Response to request for Additional Information

Planning Authority: South Dublin County Council
Applicant: Better Value Unlimited Company

PA Ref: SD22A/0316

Date: 25 October 2022

Figure 2: Locations of Creches in wider area.

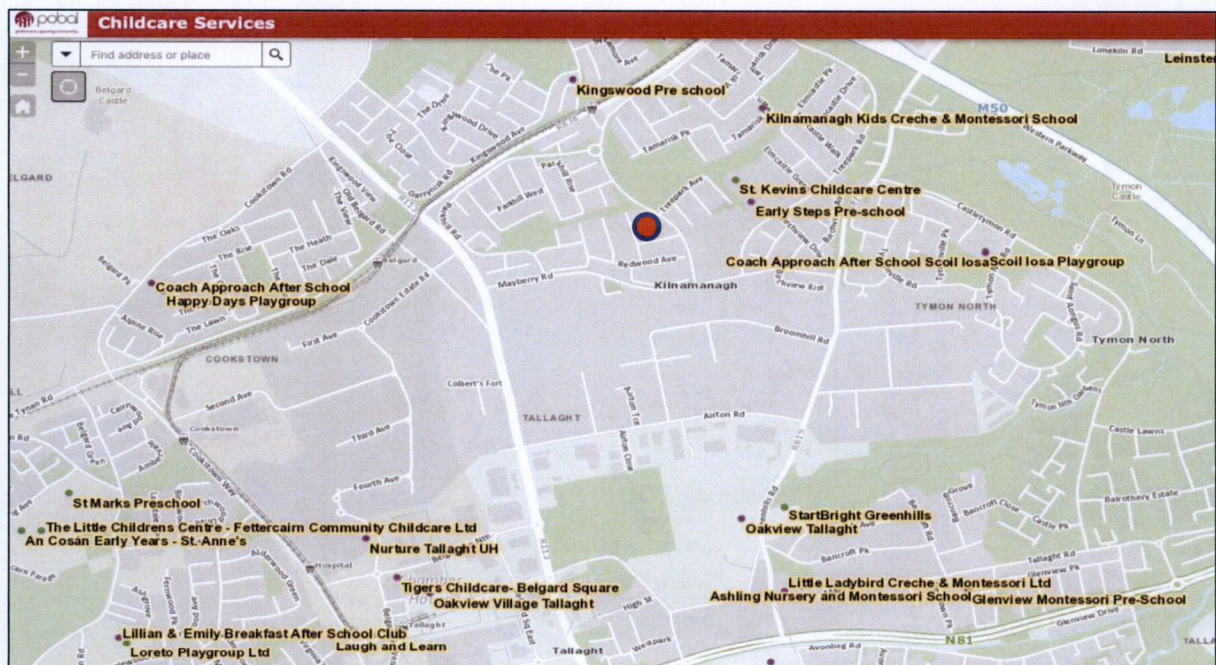
- Provision of a creche is not appropriate at this centre given the need to provide external play space for children in a manner that is safe and connected to the creche itself.
- There is St Kevins Childcare and Early Steps Pre-School located at St Kevins beside the application site.
- There are already a vast number of creche and childcare services in the immediate and wider Tallaght area that already service this market as indicated below.

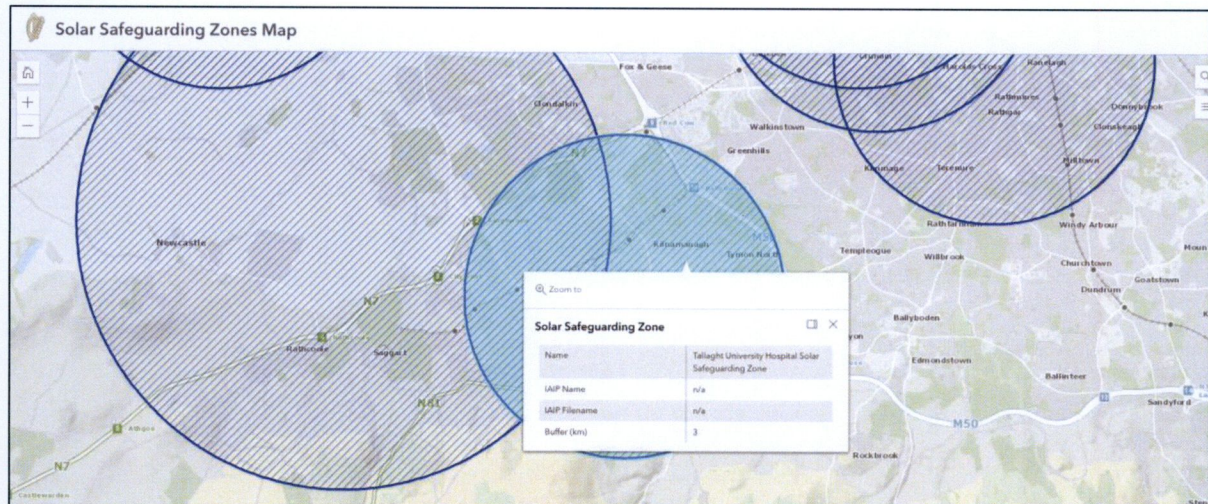
The County Development Plan encourages the use of renewable energy at employment sites and the use of solar panels. The applicant is invited to consider the possibility of ‘greening’ the development by installing solar panels on the roof of the shopping centre, by way of additional information.

PDA plan PL 109 includes a roof plan showing the potential location for PV solar panels. This does not form part of this application as the feasibility of same is being reviewed by the Structural Engineer. The initial feedback is that this location should be structurally suitable.
